PROJECT: TUBE KICK		
DESIGN TITLE: Prototype - MIXED BIAS		
AUTHOR: Laurent	DRAWING NUMBER Drawing_nr	REV: VC1
DATE: 2015-08-03	SIZE: A4	SHEET: 1 of 1

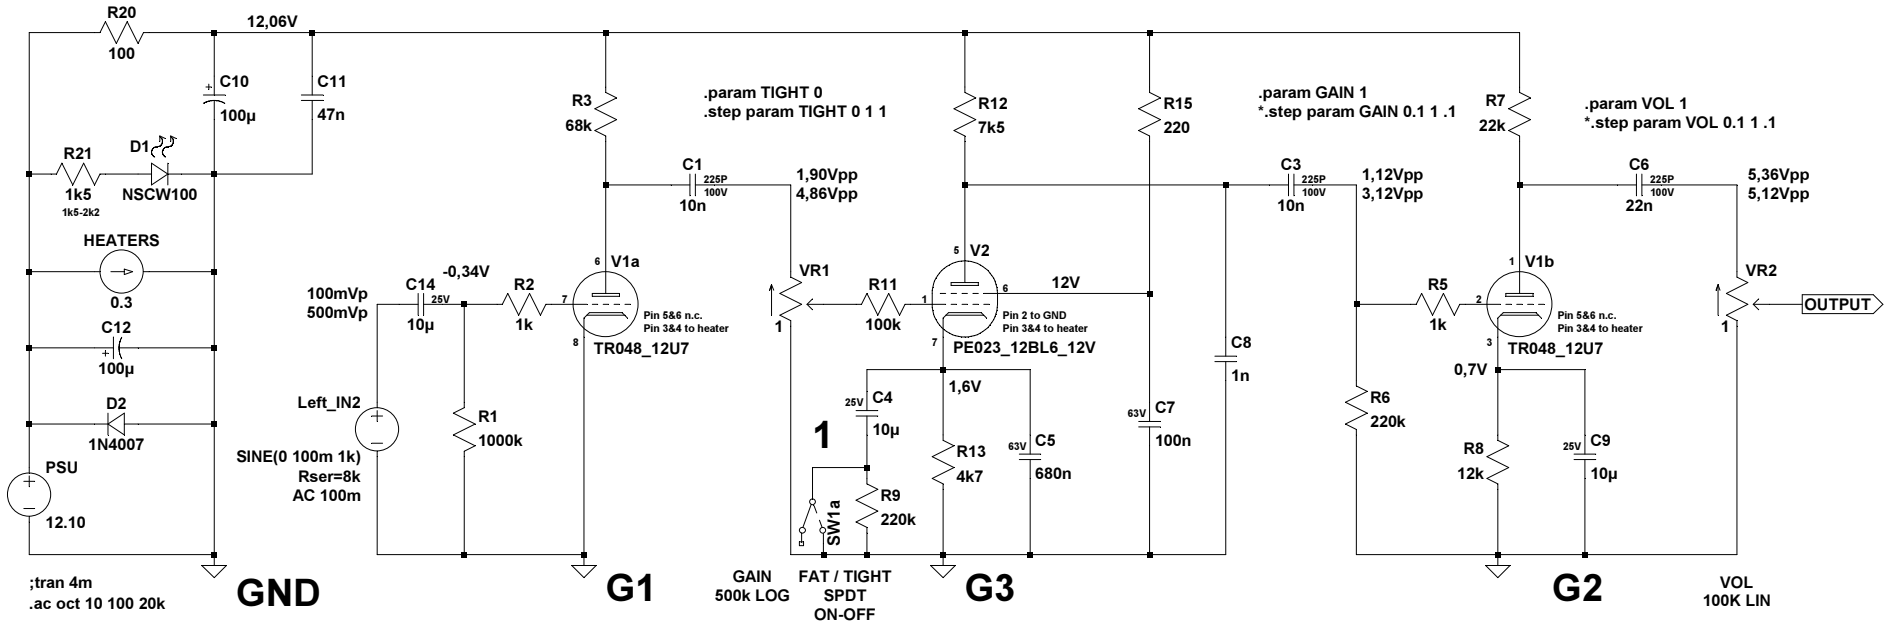
1- PENTODE MOVED TO 2ND STAGE
2- TIGHT MODE IN PENTODE CATHODE CIRCUIT (MORE EFFICIENT)
3- ADDED A OUTPUT VOLUME POT (SIGNAL LEVEL HIGHER)
4- KEPT C8 AT OUTPUT OF 2ND STAGE
5- TESTED 470K FOR R6 BUT WAS NOT WELL SOUNDING

A- INCREASE R1 TO 2M2 TO GET BIAS OF ABOUT 0,45V
B- REDUCE R8 TO 7K5-10K (CHECK EFFECT ON DISTORTION)
C- TEST AGAIN VALUES FOR C5 FROM 220NF TO 1UF
D- TEST CATHODE BIAS FOR 1ST STAGE AGAIN.
